Spare Parts Requirements for Rear Cardan Shaft: Checking Heat Shield (14/15)

Model Line: **Panamera**

Model Year: **As of 2010 up to 2013**

Information: **Modified heat shield**

Figure 1

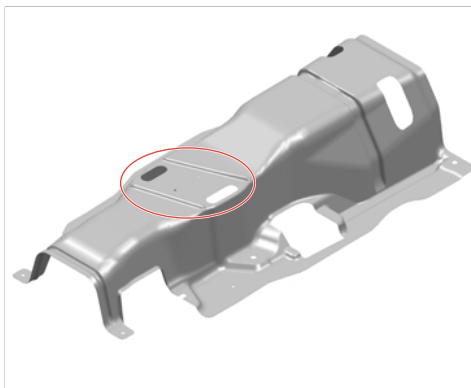
- old type: **without** cover on assembly bores (⇒ *Figure 1*)

- new type: **with** cover on assembly bores (⇒ *Figure 2*)

- old type: 970.504.561.01
- new type: 970.504.461.01

If the cardan shaft needs to be replaced, the type of heat shield installed must be checked.

Depending on which type is installed, the heat shield may have to be replaced.

Replace heat shield, see ⇒ *Workshop Manual '393519 Removing and installing rear cardan shaft'*
